Discovery Point, Wolli Creek Concept Plan

Building 8 Envelope Parameters

Scale	1:250 @ A1 , 1:500 @ A3		
Drawn	AW	Checked	MA
Project no.	S11191		
Status	PLANNING		
Plot Date	23/08/2013 2:34:41 PM		
Plot File	\\oxf-vfp-01\home\$WAY\Documents\masterplan-discovery-111110_C		
Drawing no.	DA3-010	Revision	G

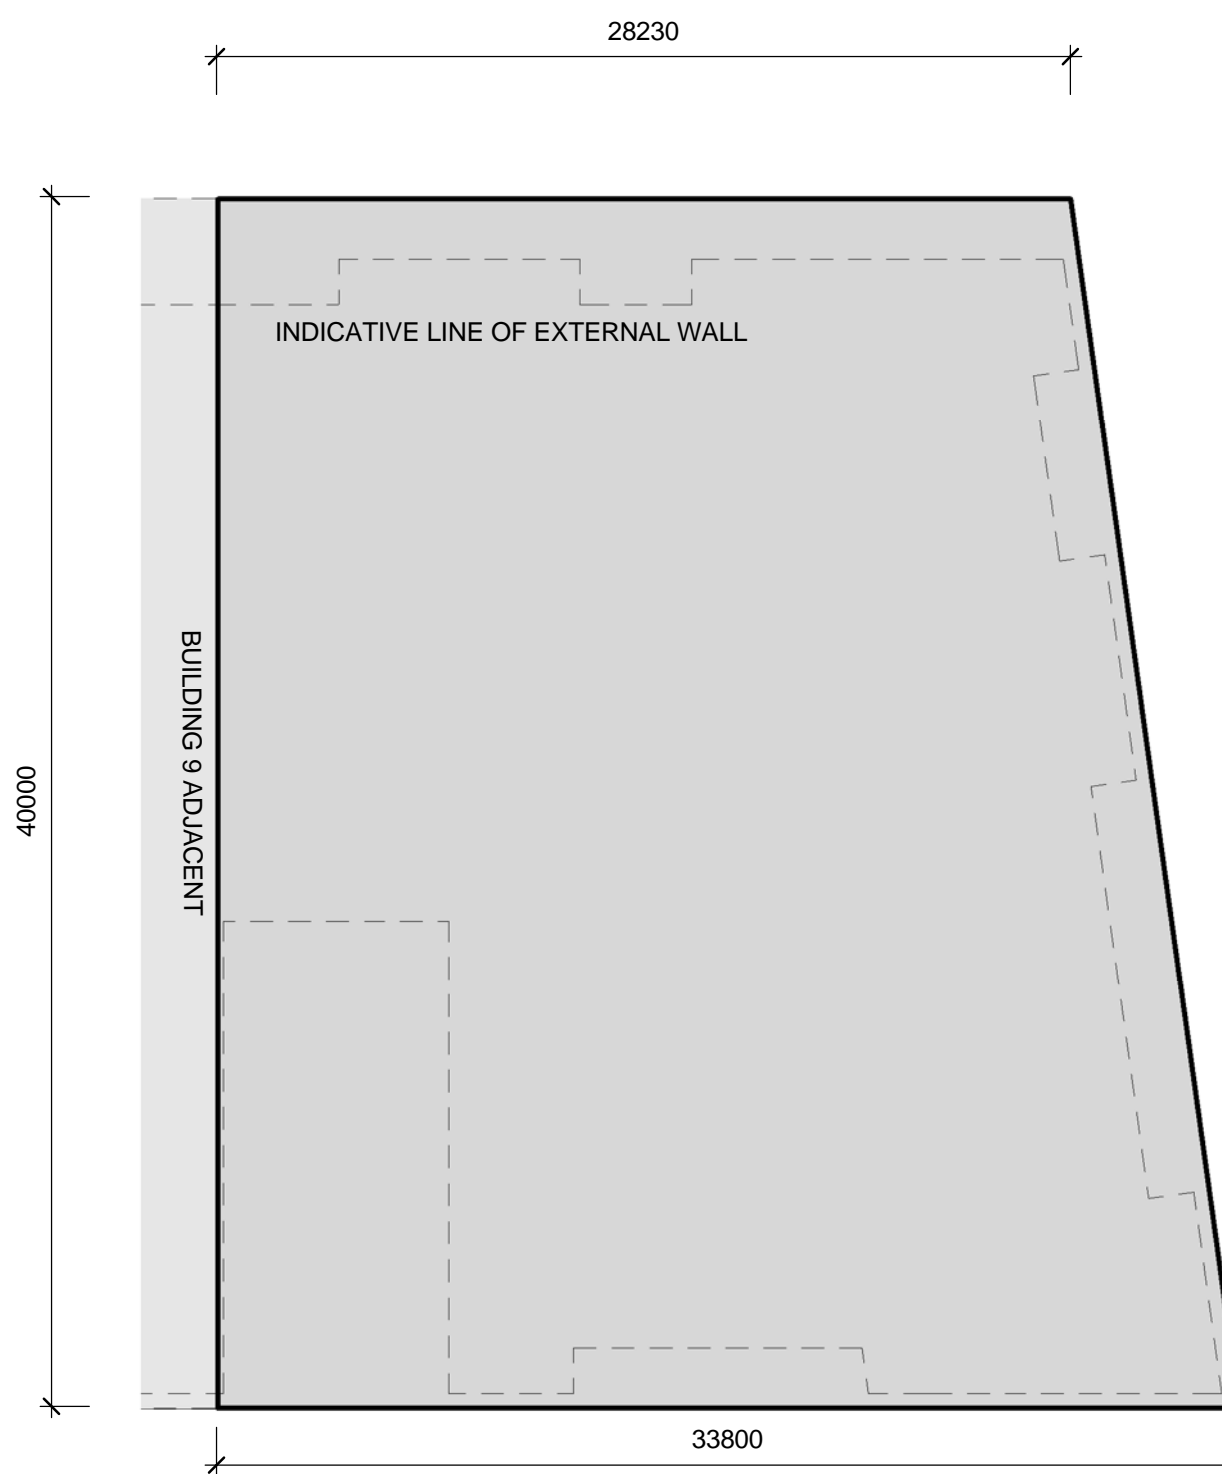
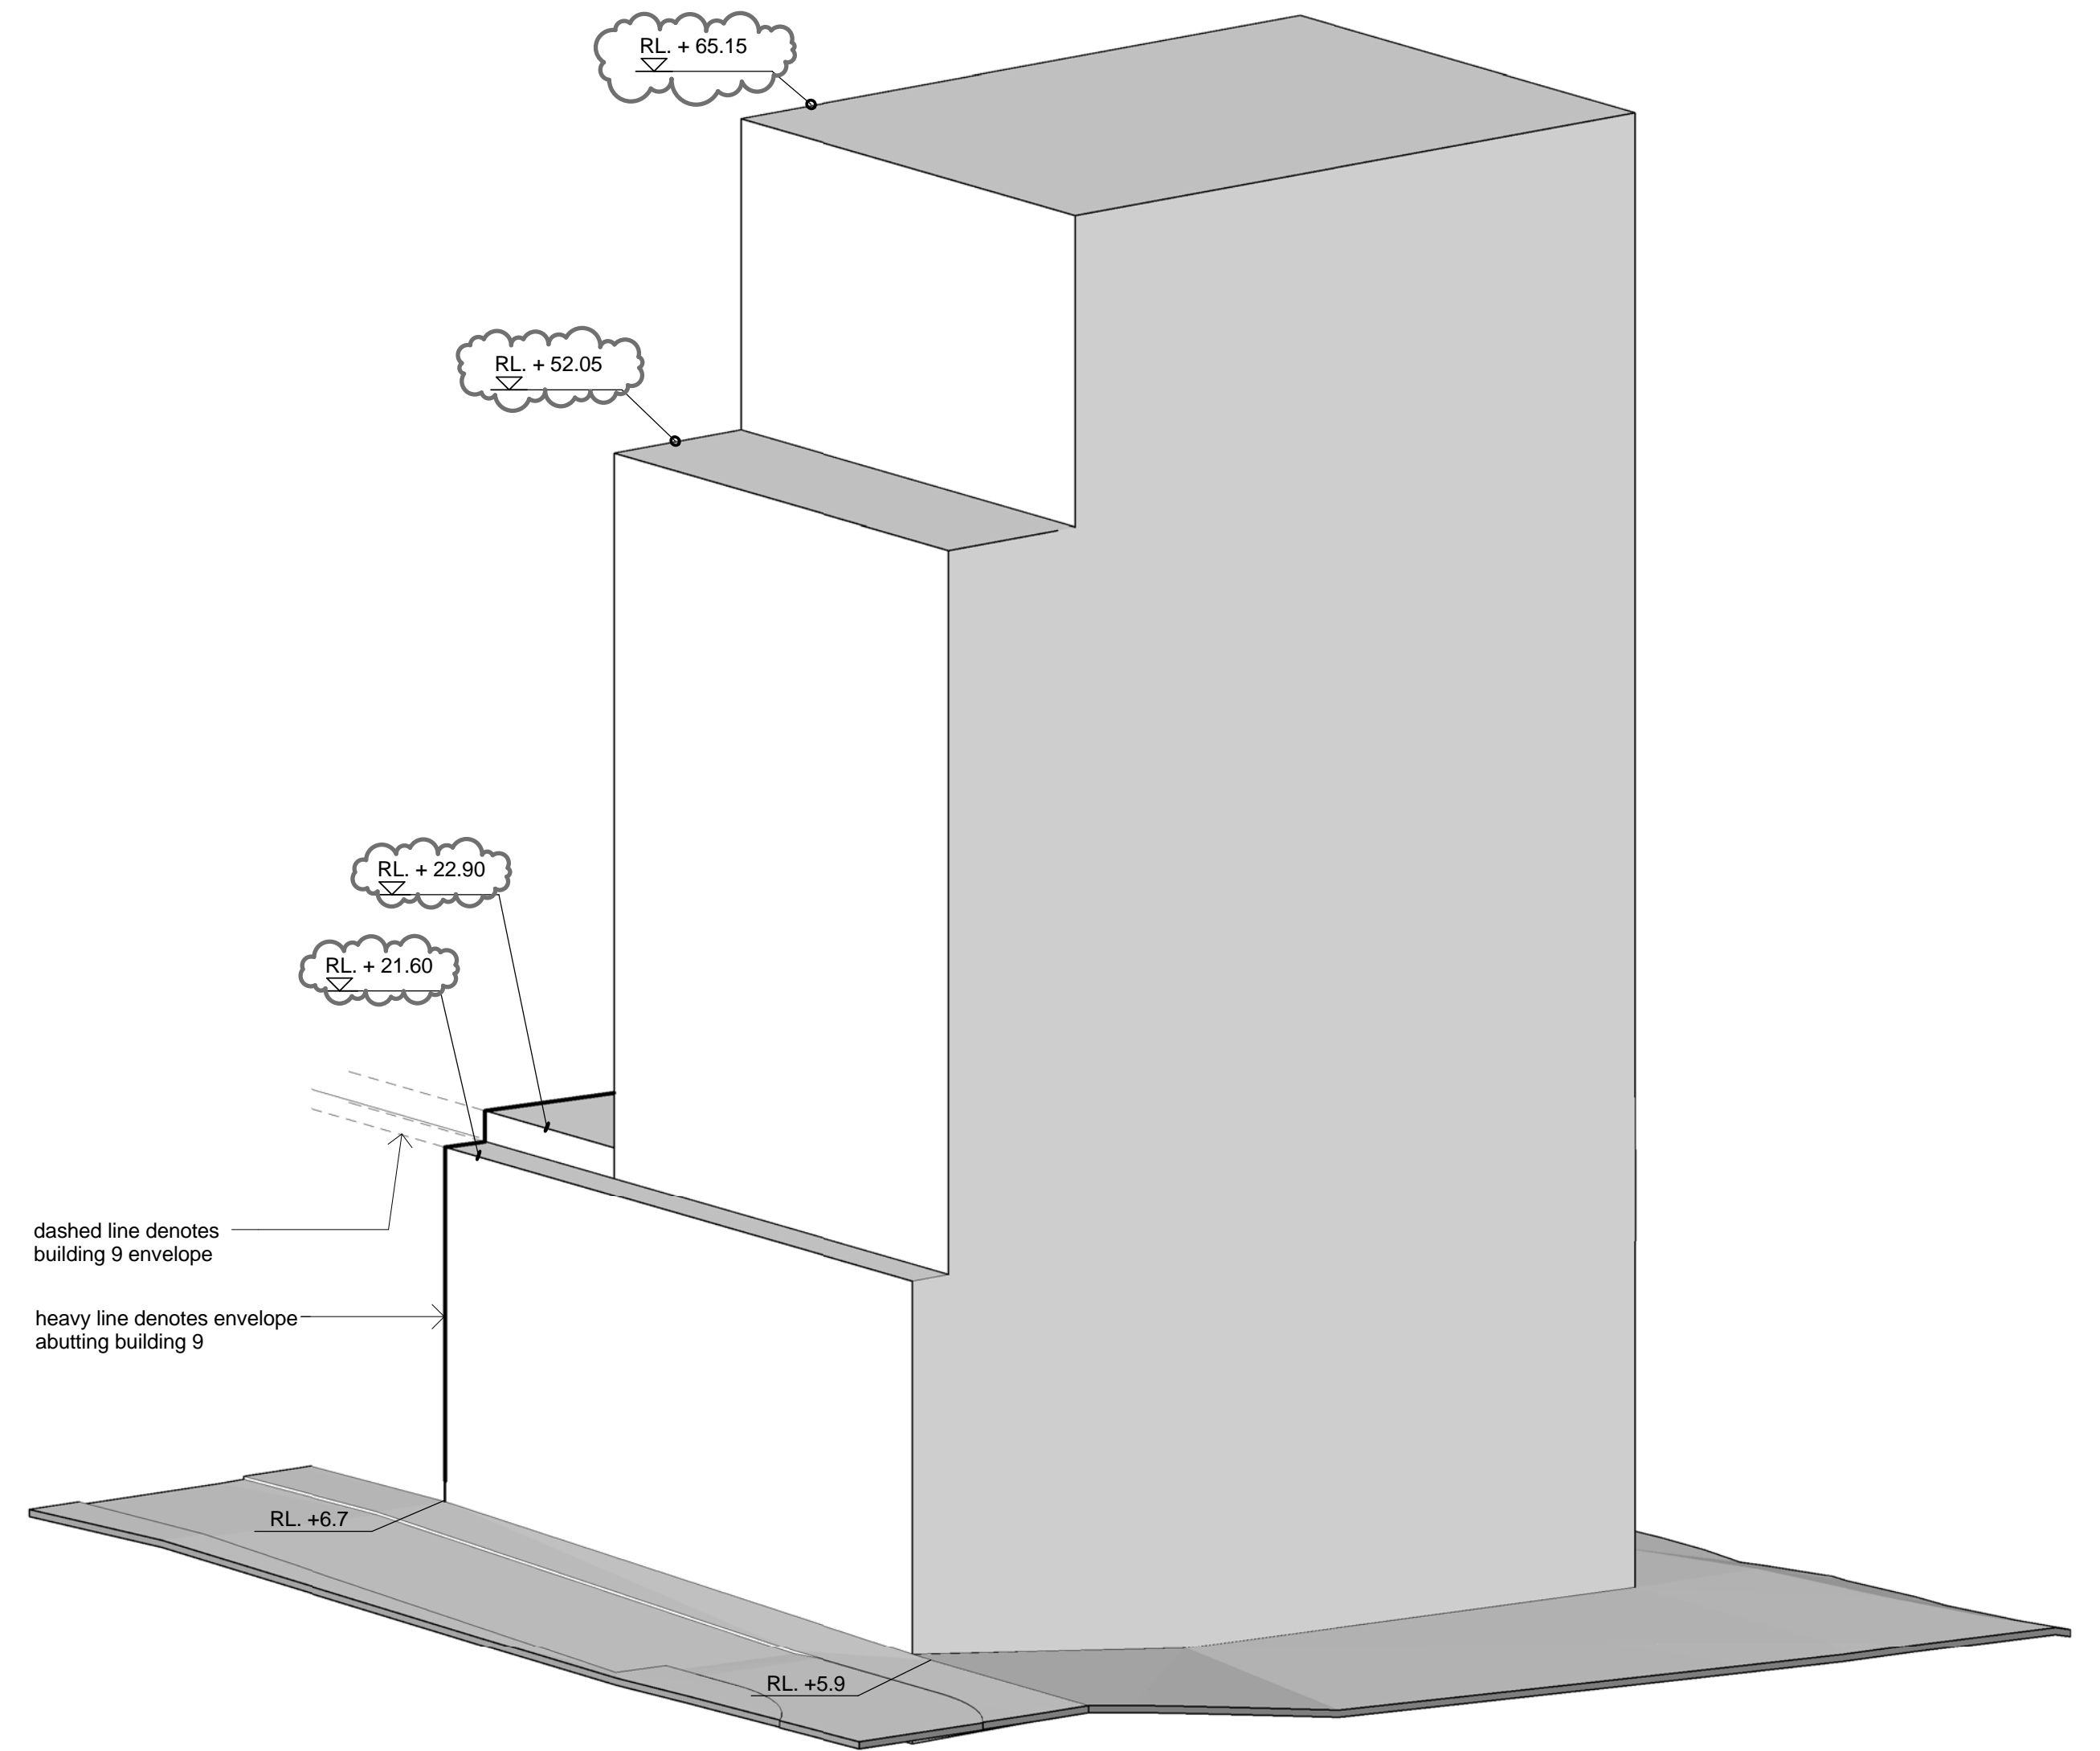
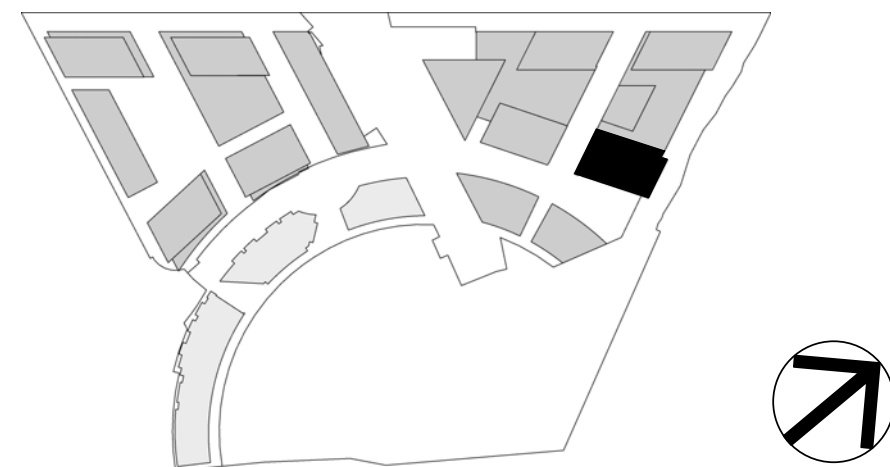
Amendments since Revision A
Envelope reduced at East, West and South to increase building separation
Setback to Cooks River Increased
Typical High Level Plan with amended Envelope increased in height, all levels
